**Metalex  
Manufacturing  
Inc.**

P.O. Item No.	Qty Ordered	Qty Shipped	Qty Back Ordered	Description
1	2	2		27H638C: MQXFA SHELL SEGMENT, END S/N: 001, 002  -CERTIFICATE OF CONFORMANCE, INSPECTION DATA, AND CERTIFICATIONS ENCLOSED.  "SHIPMENT PACKED BY: _____  "SHIPMENT CHECKED BY: _____  FOR METALEX USE ONLY:  SHOCKWATCH S/N: _____  TILTWATCH S/N: _____

**CERTIFICATE OF CONFORMANCE**

<u>ITEM</u>	<u>QTY</u>	<u>PART NUMBER</u>	<u>REV</u>	<u>PART NAME</u>	<u>ID # *</u>
1	2	27H638	C	Short Magnet Shell	001 & 002

DETAIL D  
SCALE 1.000

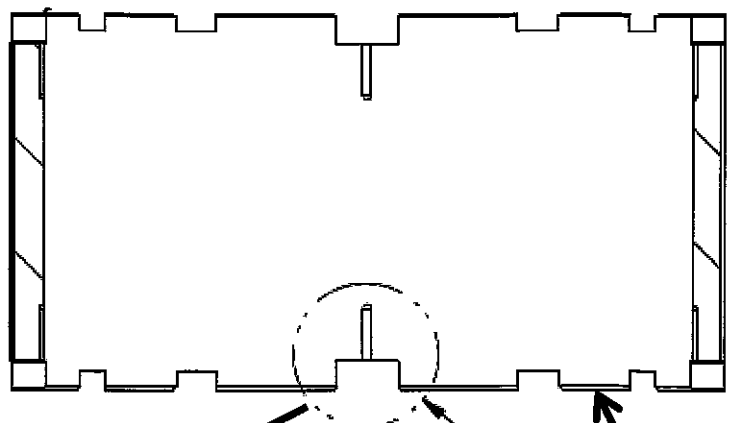
Per Drawing 27H638, Sheet 1, Zone H7:  
Minimum radius of .030"/.060" typ in corners of (8X) slots

(4) slots on Datum B end of S/N 001 have sharp corners (up to 0.005" radius) per old Rev. BV drawing

The CNC program status was marked as "Edit" on 1/13/17 for the added radii, but this status was automatically changed to a "C" when the machine number was changed in the program maintenance software, and therefore the Program Edit was never scheduled to be put onto a Programmer's schedule to revise the CNC programming.

The Program Maintenance software was revised to have a Change or "C" status show on the schedule over an Edit or "E" status. This logic has been changed so that the Edit status is priority.

Work Instruction MXWI5040 will be updated and revised to provide clear instructions on what is required by the Programming Coordinator for various program statuses. The Programming Coordinator will be trained on this updated process and it will prevent programs from being released to the shop floor that are not in a correct program status.

The shells will be accepted with sharp  
inside radius
